**Responses to NRC Letter Dated August 19, 1997 and December 5, 1997, Regarding NRC  
Acceptance Review of the Reclamation Plan for the White Mesa Uranium Mill**

**Source Material License SUA-1358  
Docket No. 40-8681**

**Response to Nuclear Regulatory Commission / White Mesa Mill Reclamation Plan  
Comments Dated August 19, 1997  
Source Material License SUA-1358**

**Response to Nuclear Regulatory Commission / White Mesa Mill Reclamation Plan  
Comments Received December 8, 1997  
Source Material License SUA-1358**

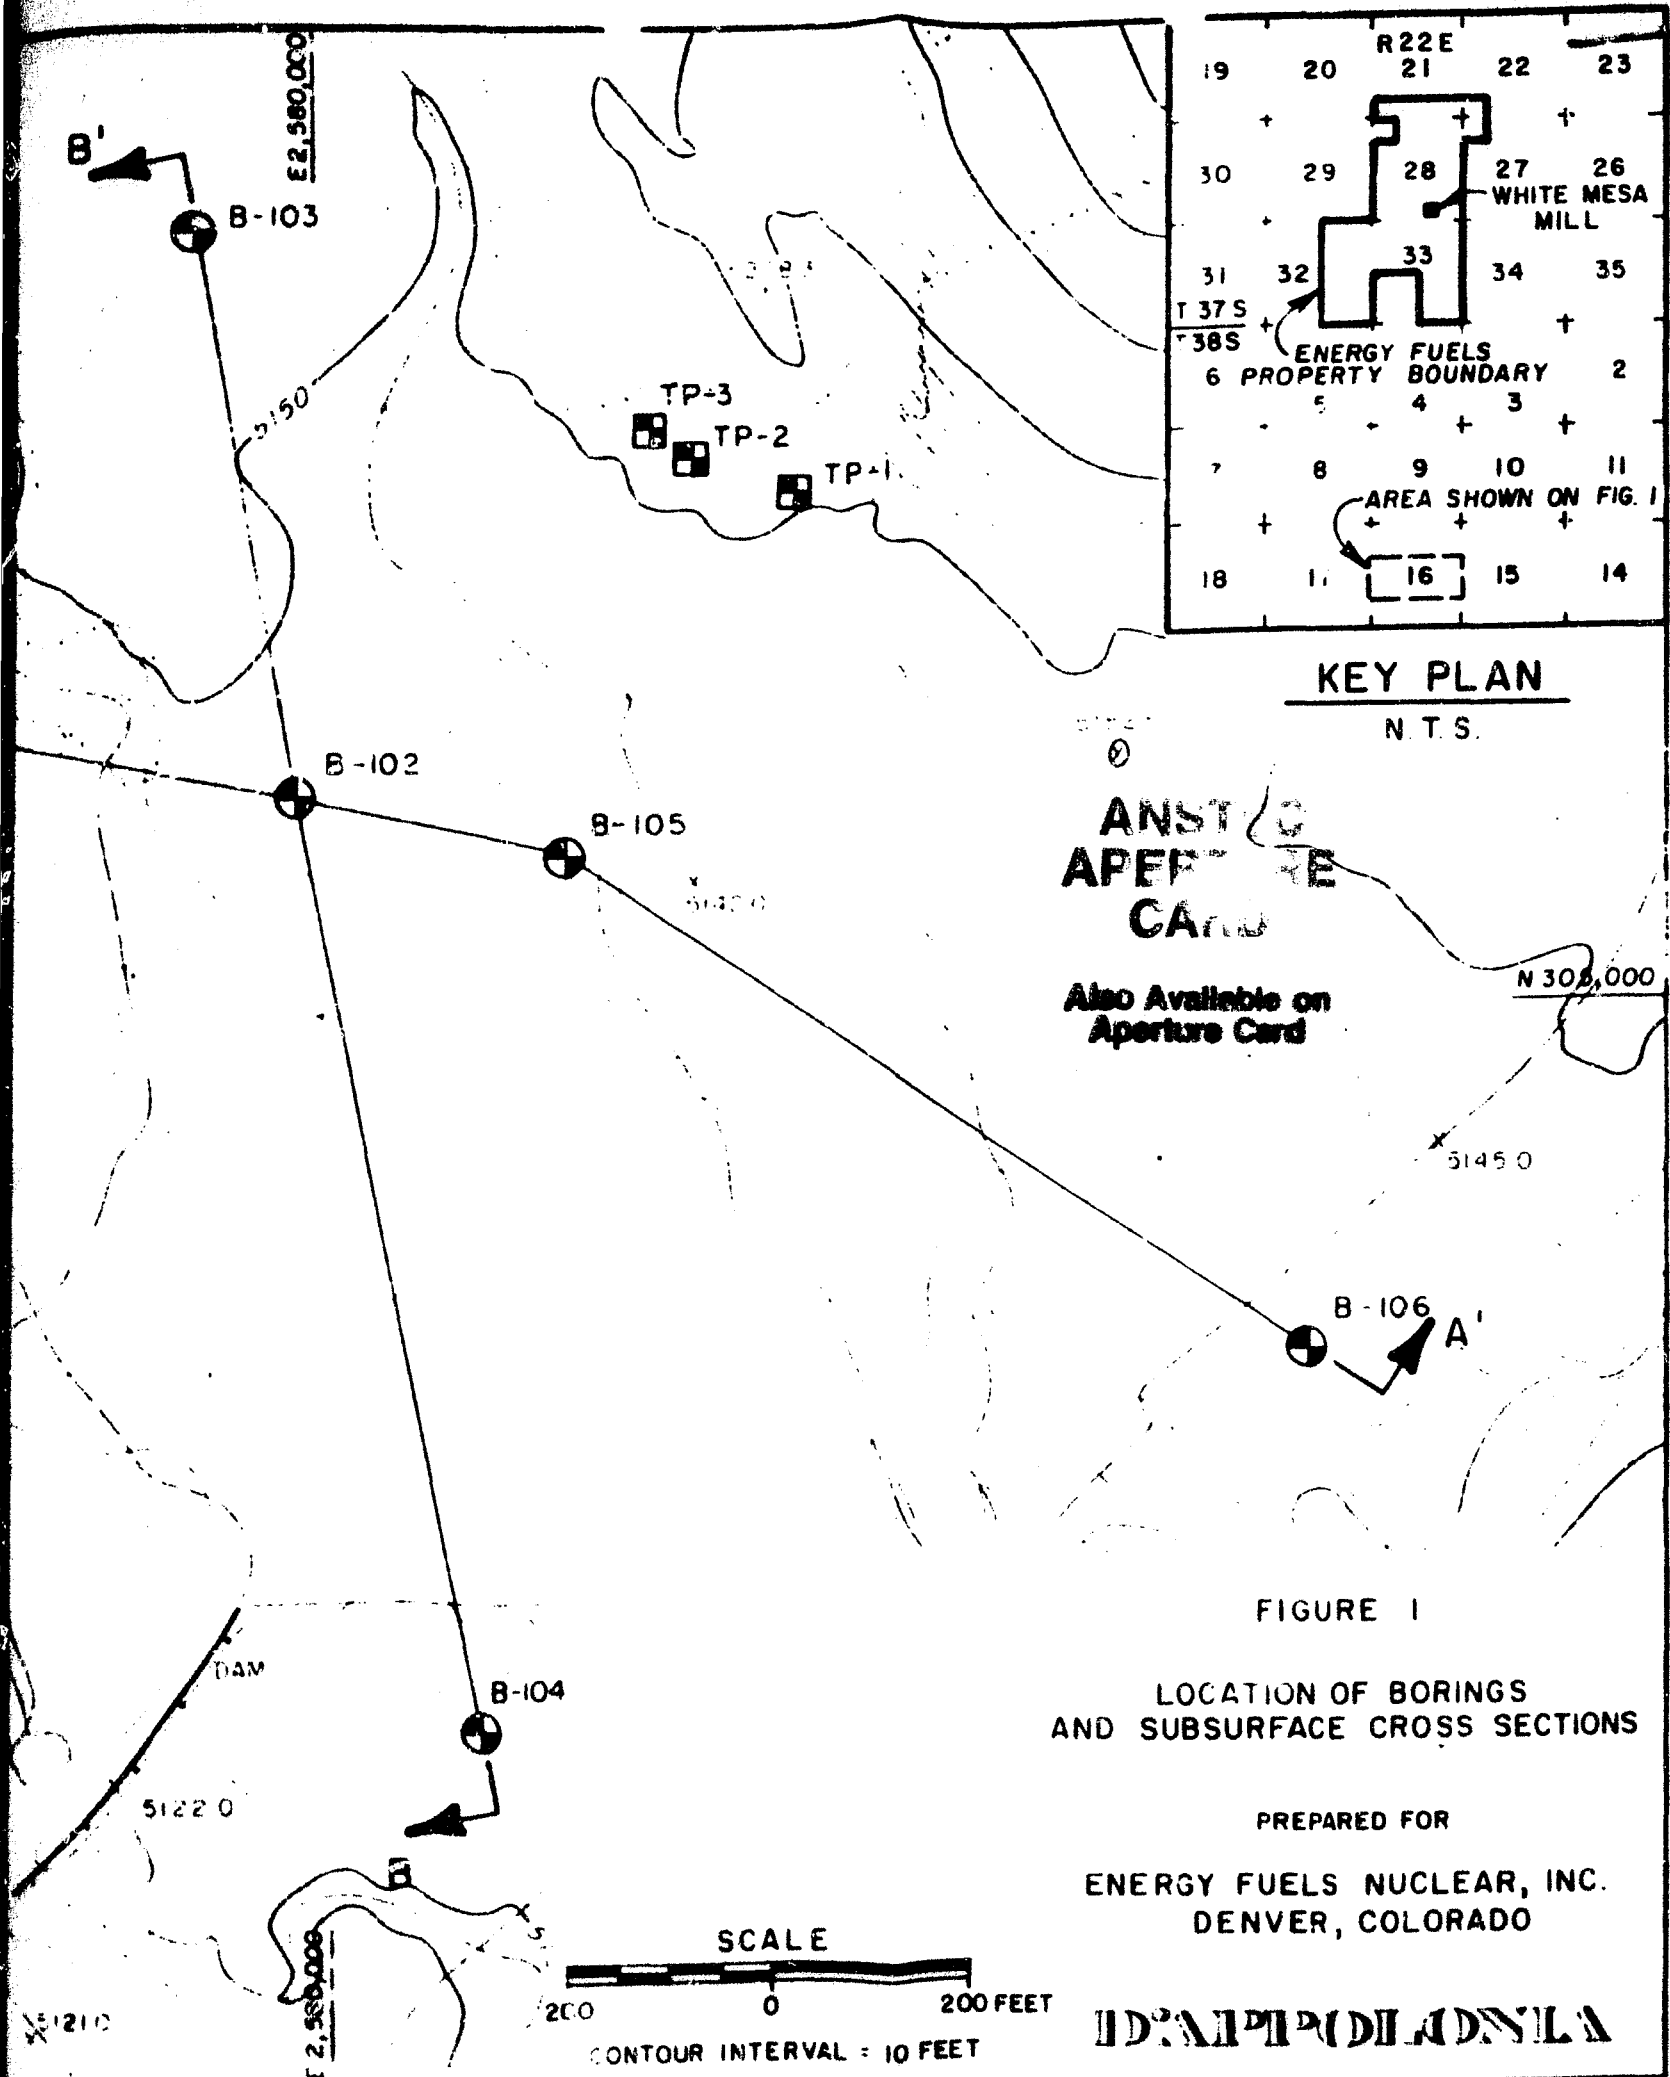
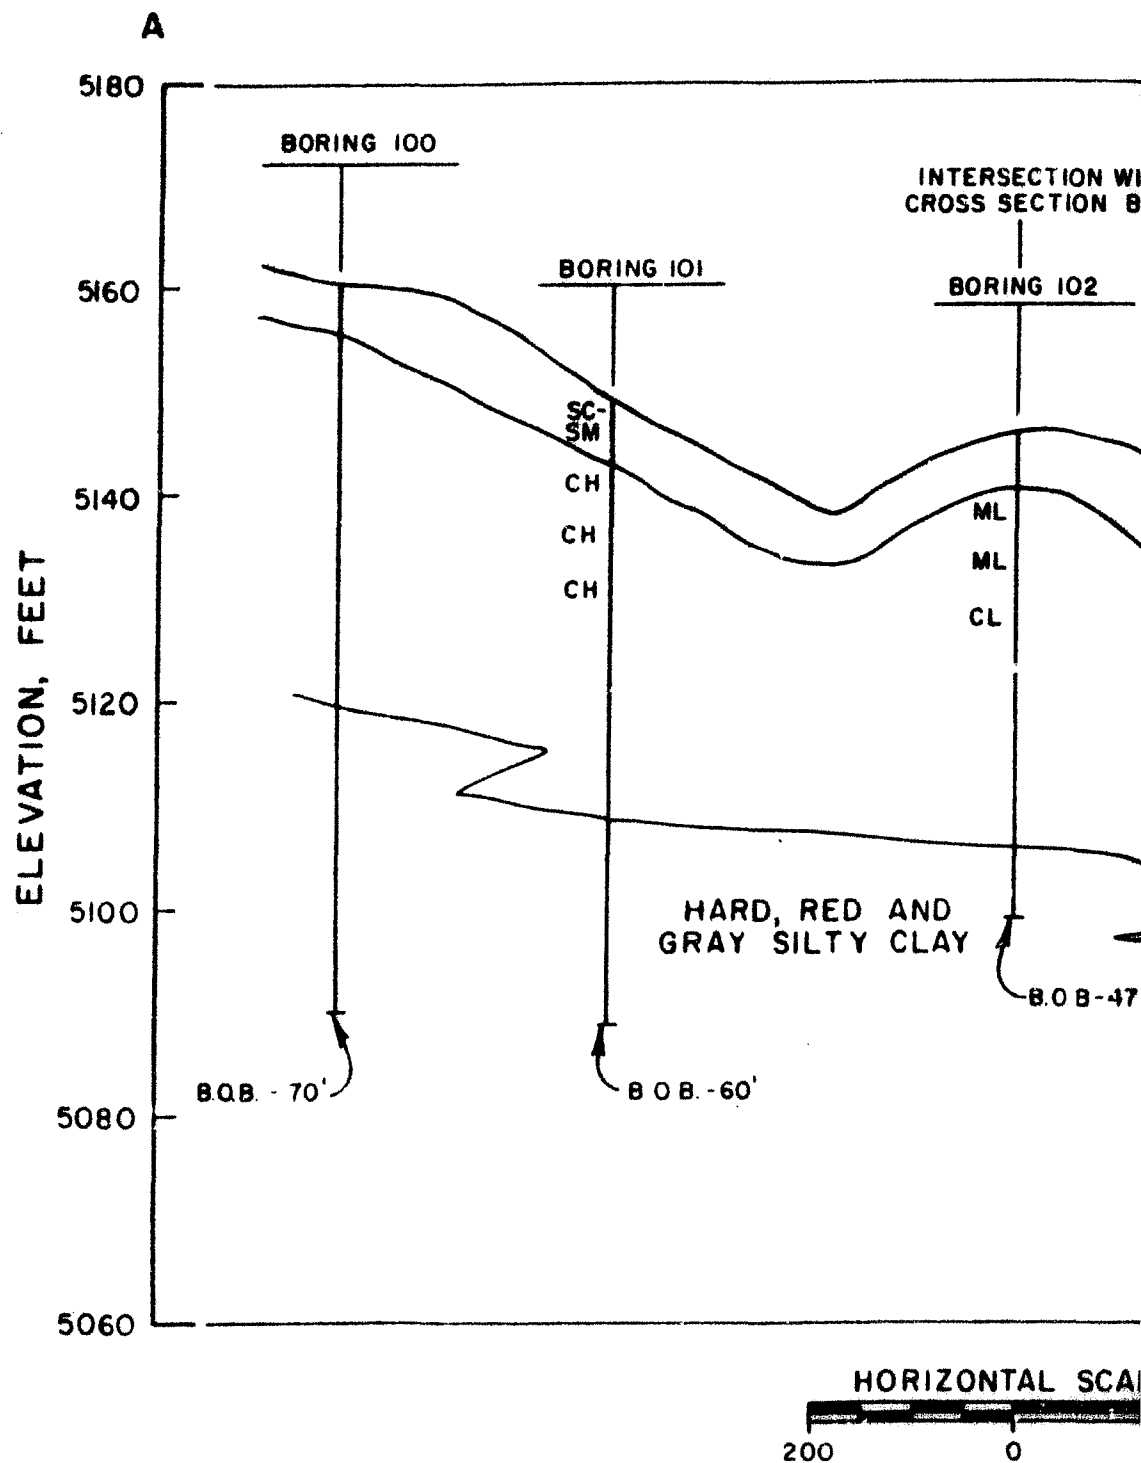
The clay materials were identified in the Section 16 area encompassed by borings B-100, B-103, B-104 and B-106 as shown on Figure 1 contained within Attachment 1 of this response. The surface area between these borings is approximately 1,160,000 square feet. The average depth of CL and CH materials encountered in the seven borings is approximately 44 feet as indicated on Figure 2 contained within Attachment 1 of this response. Based on the surface area and average depth estimated from Figures 1 and 2, the quantity of clay material available is approximately 1.8 million cubic yards.

The area of investigation is a canyon located in Section 16, about three miles south of the mill site. Seven borings were drilled as part of the field investigations. These borings, 100 through 106, are located approximately as shown on Figure 1.

Three test pits (1-3) were excavated to obtain bulk samples for laboratory testing. The location of the test pits is shown on Figure 1.

Samples from Boring 2-16 drilled by Energy Fuels in November 1978 were also provided to D'Appolonia for testing. The location of Boring 2-16 is shown on Figure 1.
